ITEM #2

Reconsideration of an approved Certificate of Appropriateness for the painting of a mural on the secondary facade

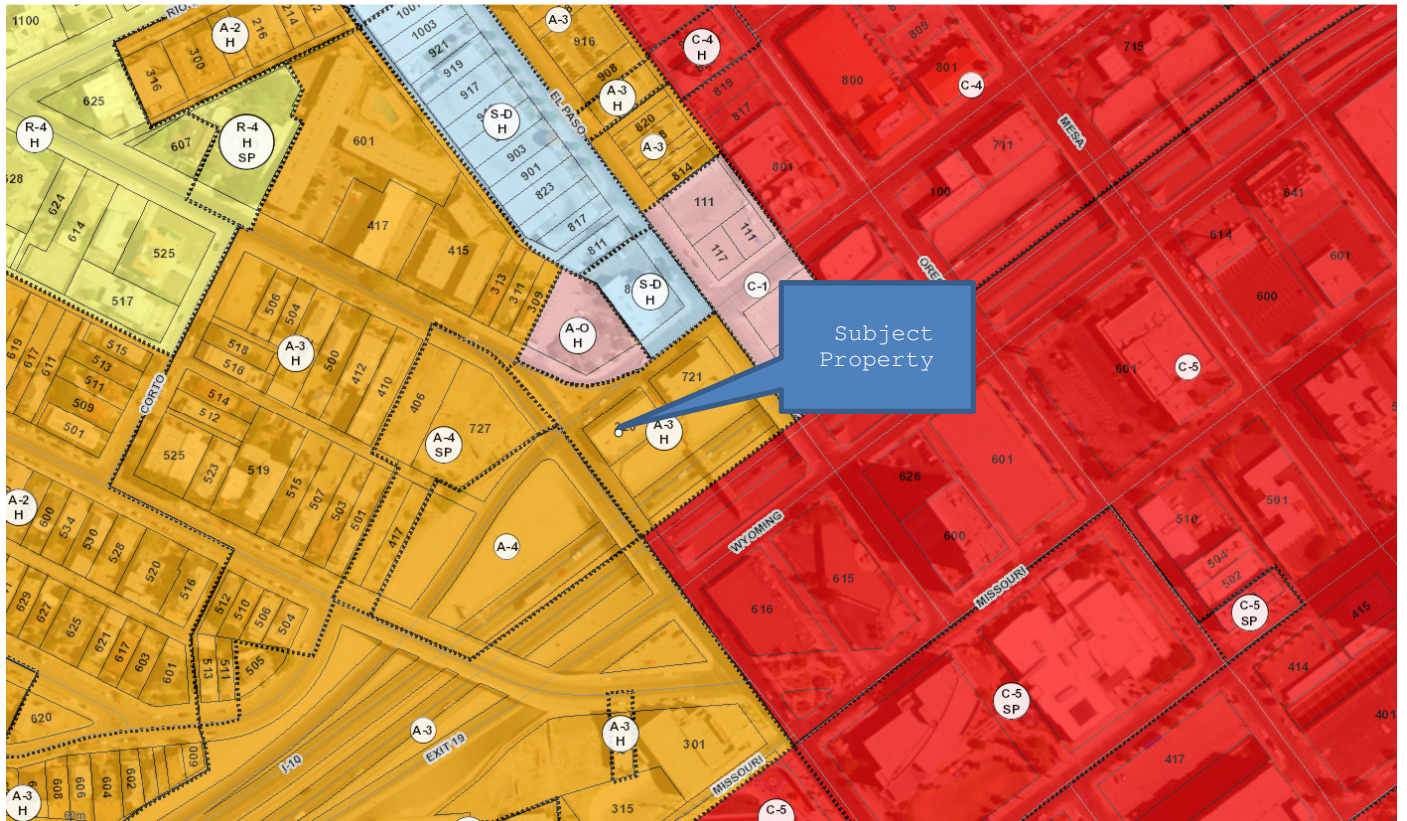
The Historic Preservation Office recommends DENIAL of the proposed scope of work based on the following recommendations:

- Painting or applying coatings such as cement or stucco to exposed masonry/stone is not appropriate, because it will change the historic appearance of the masonry/stone feature, and can accelerate deterioration. Previously painted surfaces that were painted prior to designation or with a permit may remain painted.

- The historic character of the property will be retained and preserved.
